RE: J. Leon Rutt  
Plan Review No. 2  
RETTEW Project No. 119162000

On behalf of our Client, we are hereby submitting the revised plans, and supporting documentation for the above referenced project. The plans have been revised per the Lancaster Civil Engineering Company's comments dated October 19, 2023. Our item-by-item response to each comment appears in **bold**.

RE: Preliminary/Final Land Development Plan  
For Leon Rutt  
Waiver, Deferrals and Modifications  
RETTEW Project No. 119162000

EXISTING CONDITIONS/DEMOLITION  
 PRELIMINARY / FINAL LAND DEVELOPMENT  
 FOR  
**LEON RUTT**  
 MOUNT JOY TOWNSHIP  
 LANCASTER COUNTY, PA

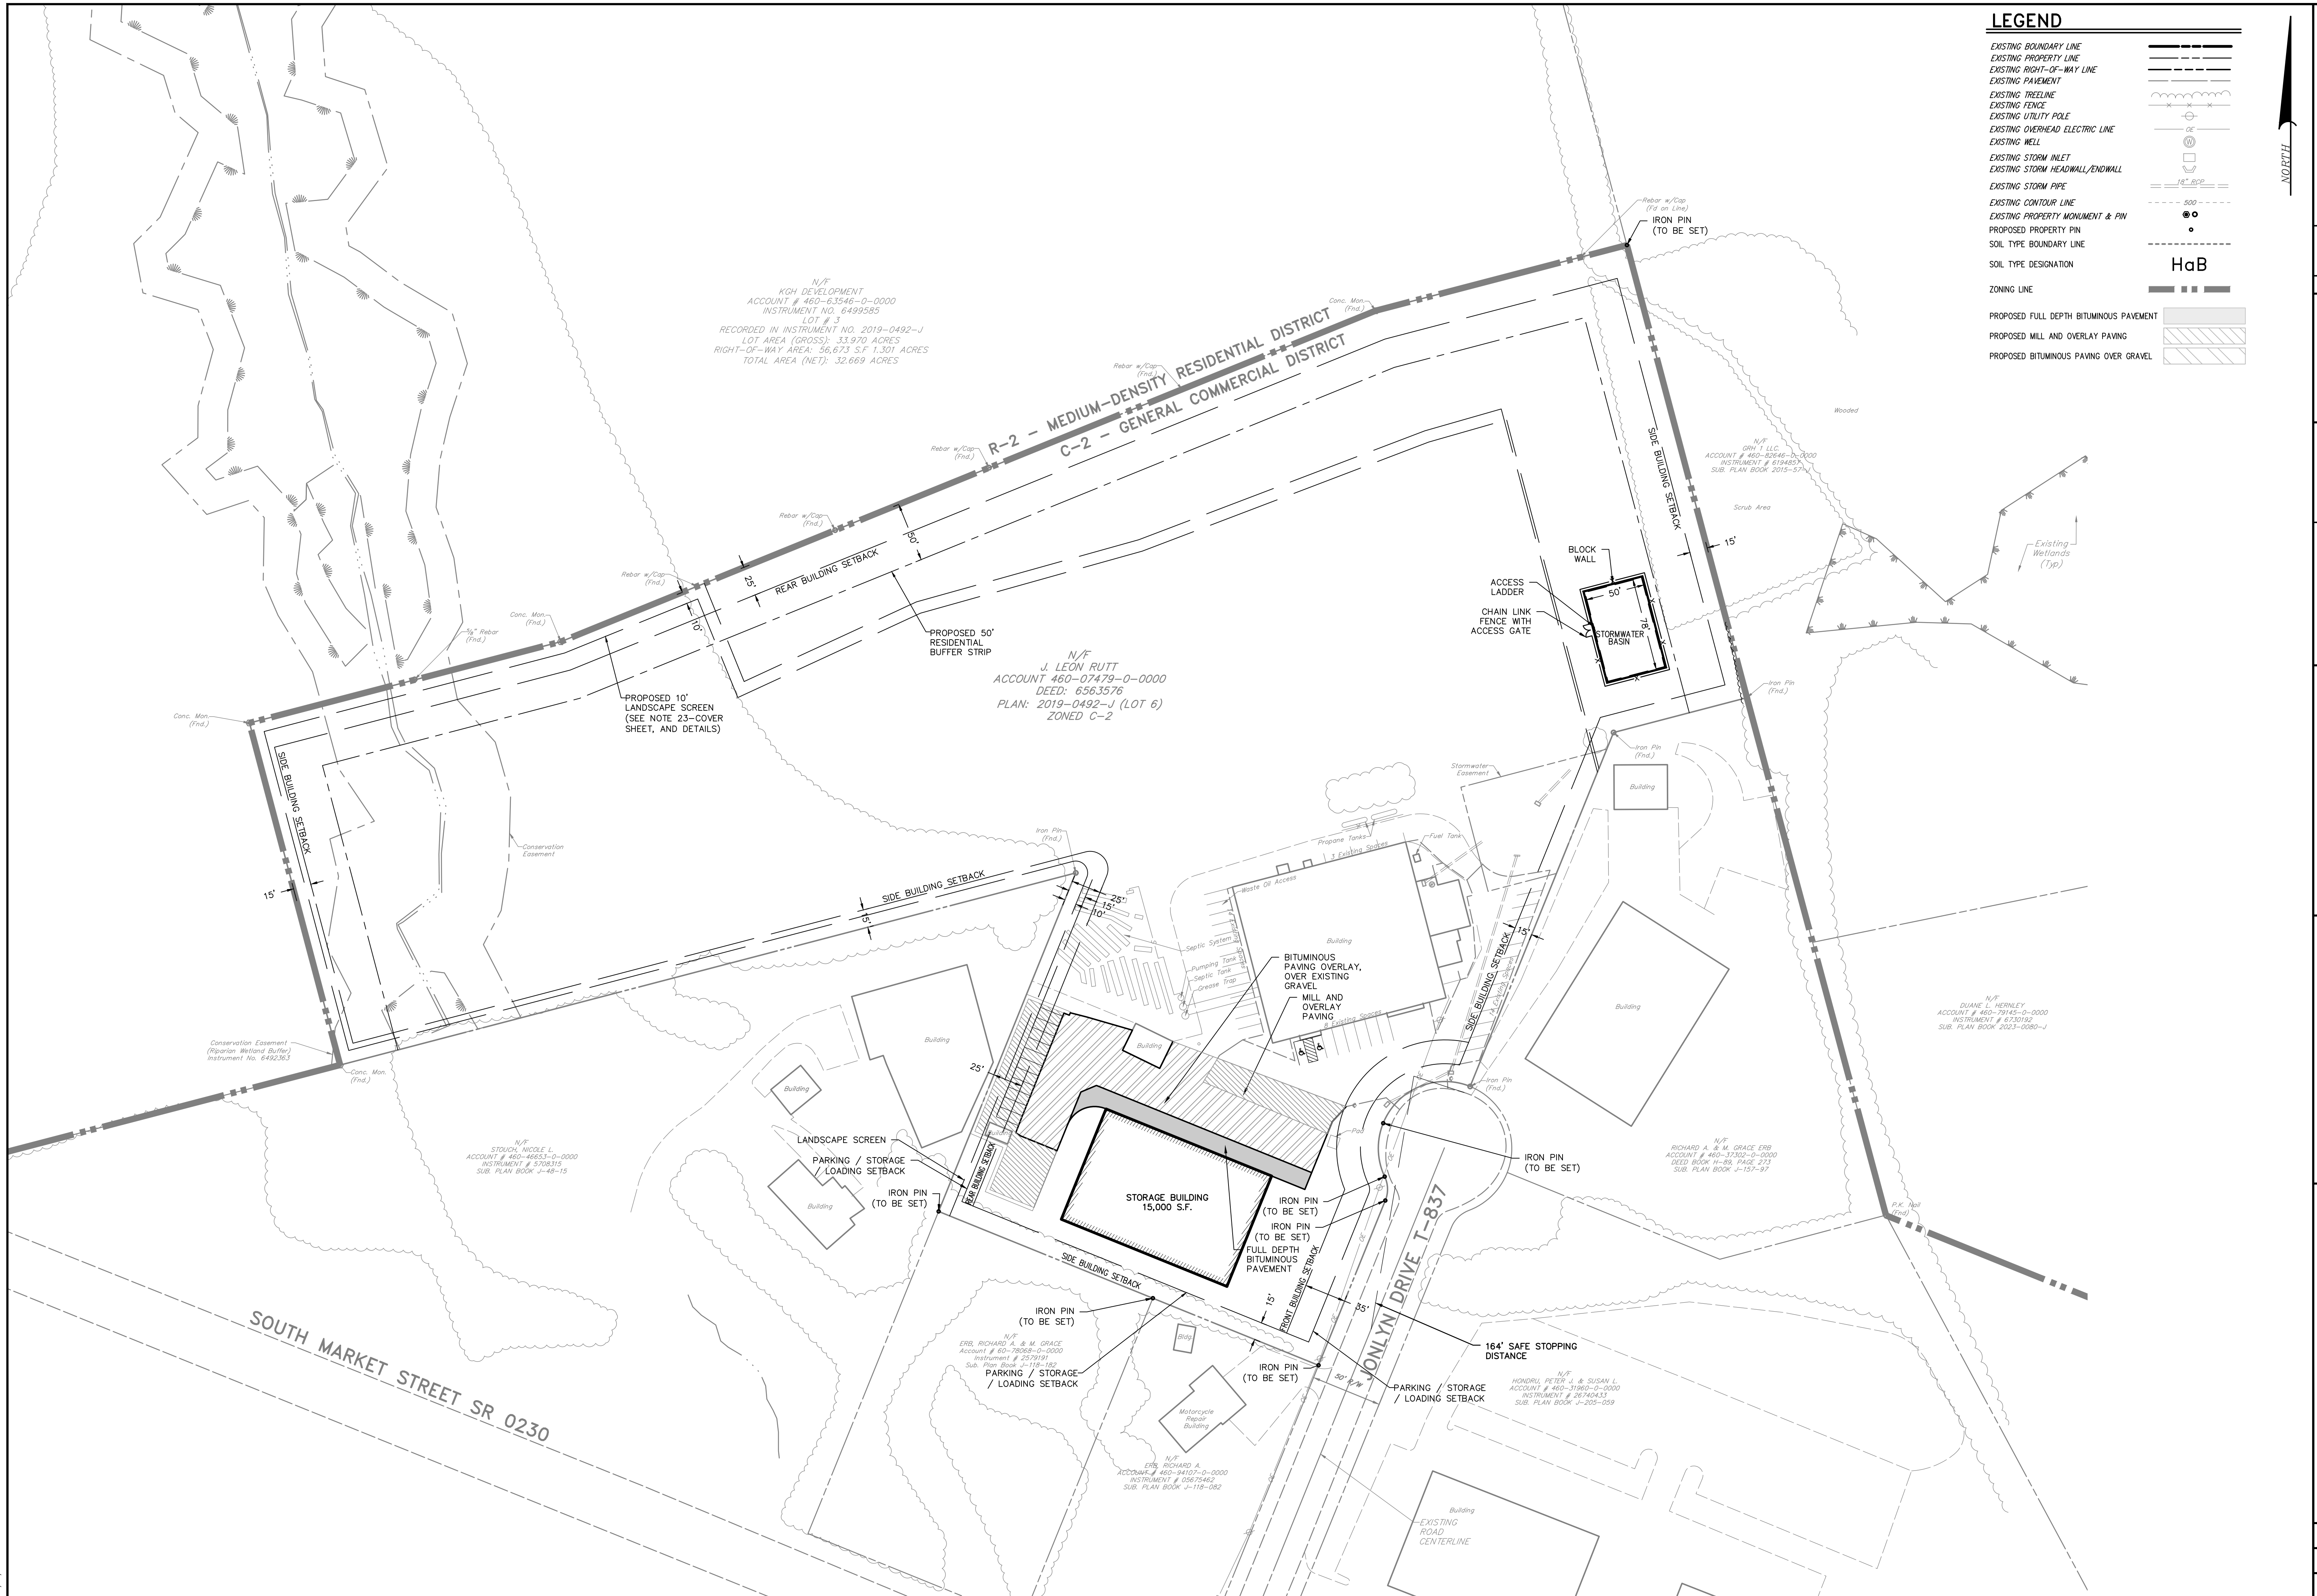
**Response: This is denoted on the cover sheet of the project.**
2. The Zoning Data table shall reference all areas included in the setback requirements (e.g. off-street parking, outdoor storage areas, loading areas, etc.) (135-135.E(1), (2), & (3)). The setbacks shall be shown on the plans.

29. The tree protection zone shown on Sheet 2 shall be extended between the existing trees to remain the limits of disturbance (113-31.N.(4)).  
**Response: The tree protection was lengthened as noted.**

**Response: The zoning data table on the coversheet was updated to include off-street parking, outdoor storage areas, loading areas. Sheet 2 has been updated to show the parking, storage, and loading setbacks.**

<b>OVERALL SITE PLAN</b>	<b>DATE:</b> 6/2/2023
<b>PRELIMINARY / FINAL LAND DEVELOPMENT</b>	<b>SHEET NO. 3 OF 12</b>
<b>FOR LEON RUTT</b>	<b>DWG. NO. 119162000</b>
<b>MOUNT JOY TOWNSHIP</b>	
<b>LANCASTER COUNTY, PA</b>

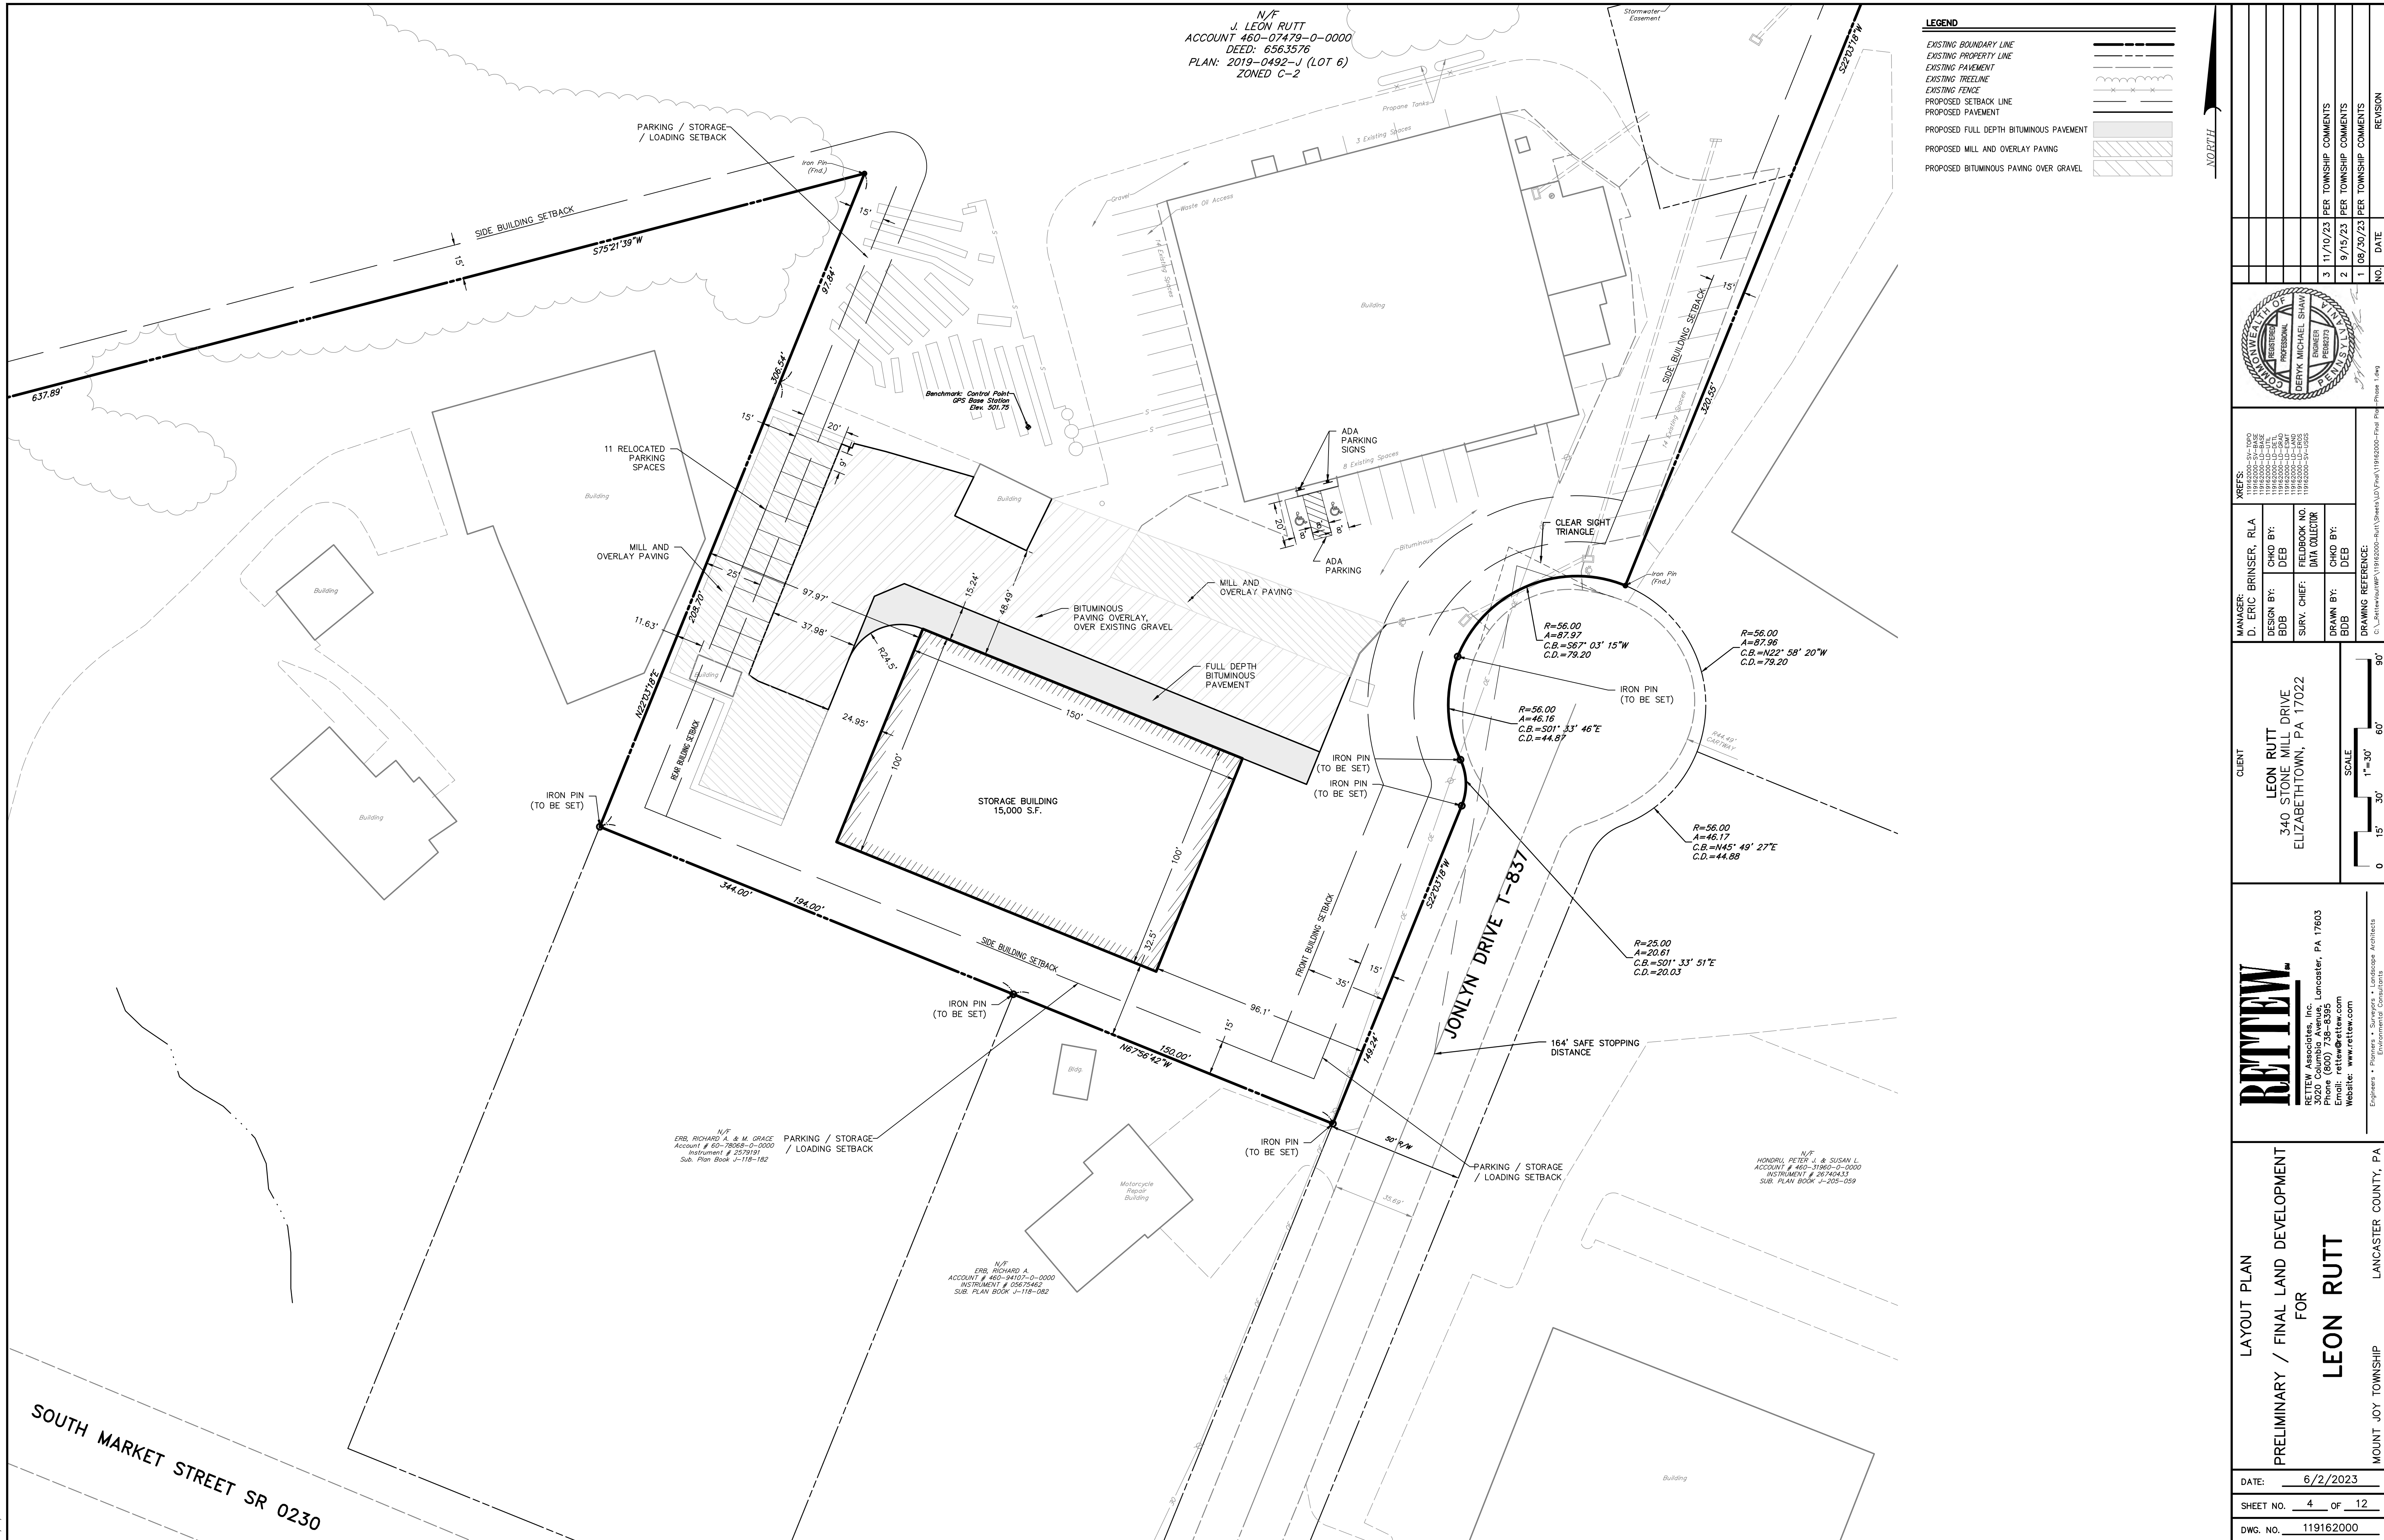
6. The plans should clarify whether each corner is already in place (FD) or to be set (119-31.D(14)). The existing lot markers and monuments shall be labeled or included in the legend.

**Response: The radius on the horizontal curve is shown on sheet 4.**
17. The paving construction details shall be consistent with the various paving types proposed on Sheets 3 and 4 (119-53.A(7)).

**Response: Sheet 3 shows all property corners that were found or to be set.**

**Response: A detail is supplied for each of the paving types, refer to Sheet 9. Mill and Overlay, Overlay, and Full Depth. This matches the labels on Sheet 3.**

**OCS-1 TO BASIN**  
HORIZONTAL SCALE - 1"=30'  
VERTICAL SCALE - 1"=3'

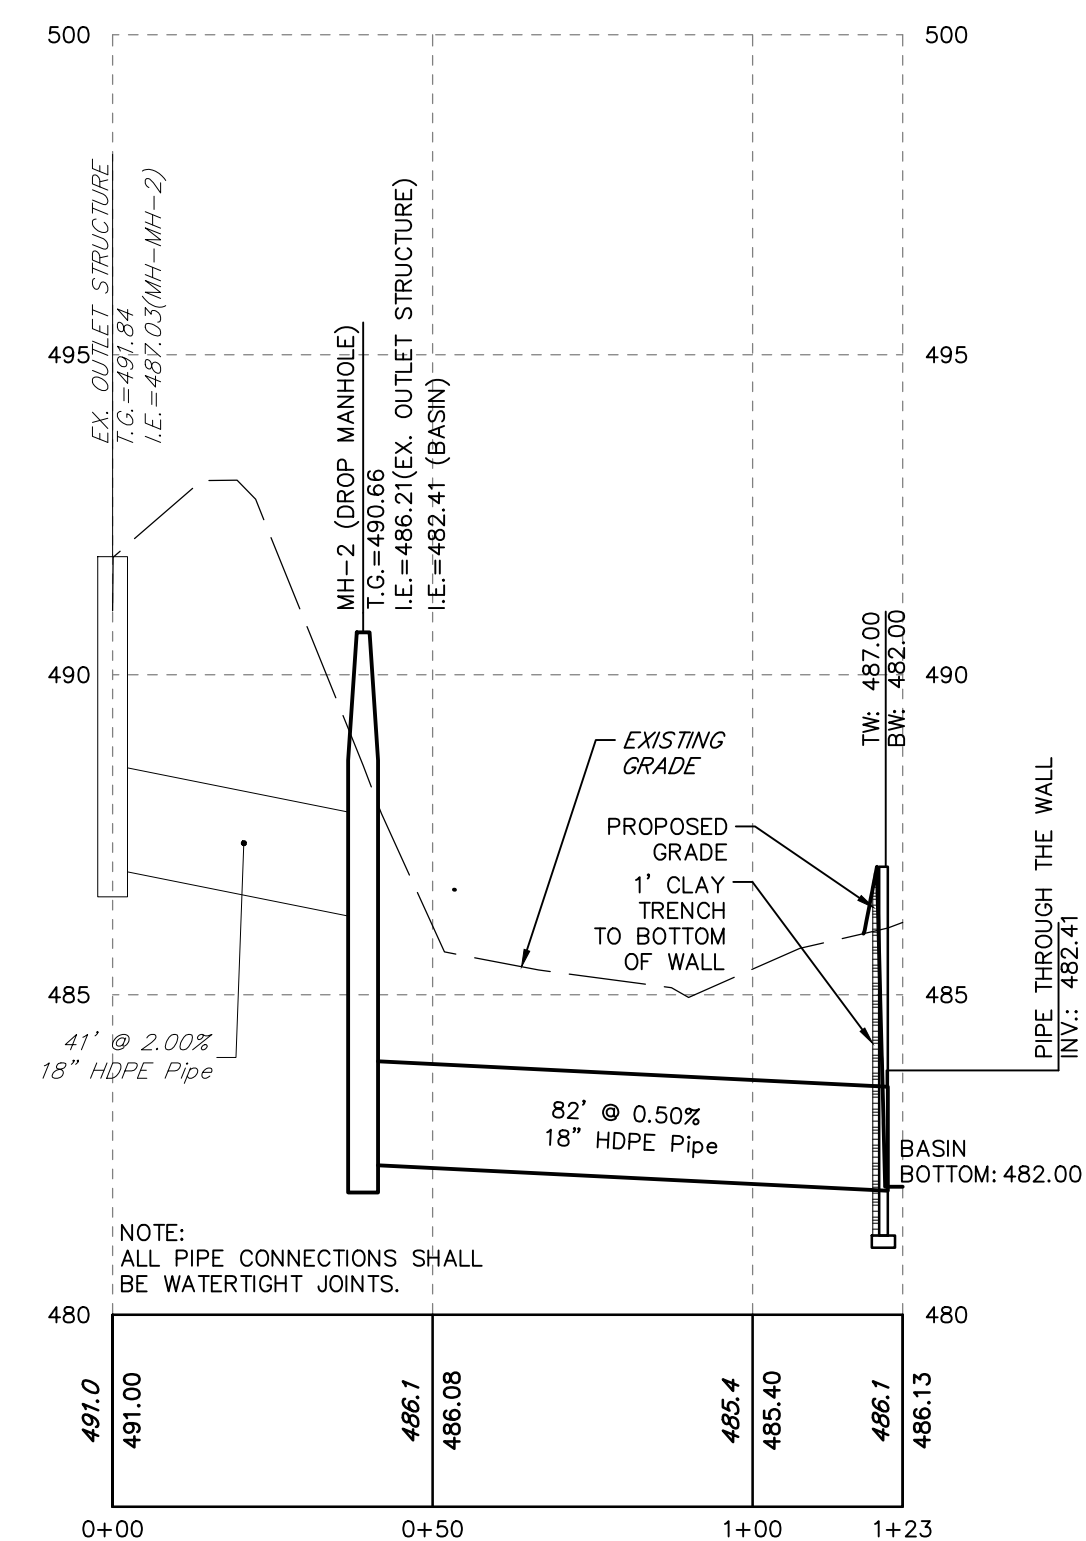
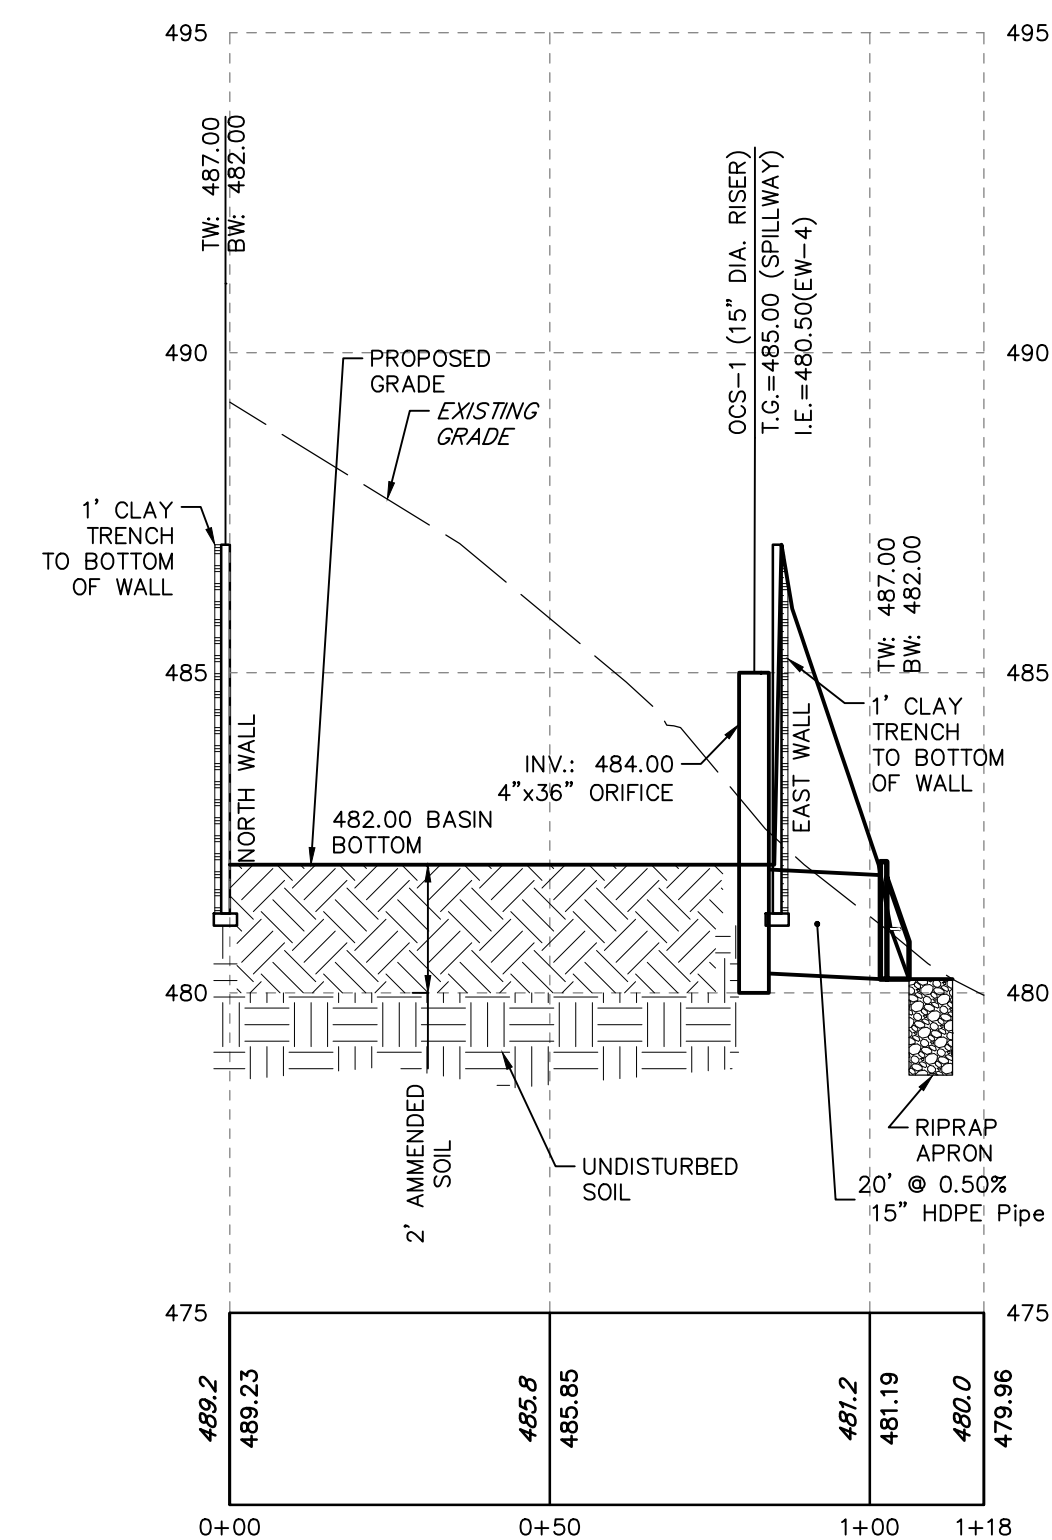
35. The conveyance calculations show that hydraulic grade lines (HGLs) for Manhole 2 is above the ground/rim elevation. This indicates that the pipes do not have adequate capacity to convey the required design storms (113-34.G).

**Response: The proposed basin has been revised and the associated details have been provided/revised to coordinate with the calculations.**
59. The ground/rim elevation for Manhole MH-2 in the conveyance calculations (485.50) is inconsistent with the elevation shown in the OCS-1 To Basin vertical profile (490.45) (113-43.J.(5)).

**Response: The storm conveyance has been revised. Please see the updated storm sewer calculations in the PCSM Report and the revised profiles on the plans, refer to sheet 8.**

**Response: The storm conveyance calculations has been revised and the associated profiles have been revised to coordinate with the calculations.**
60. Construction details shall be provided for the proposed wall in the Stormwater Basin (113-43.J(5)). Design calculations shall be provided that the proposed wall can safely contain all storms in areas of fill.
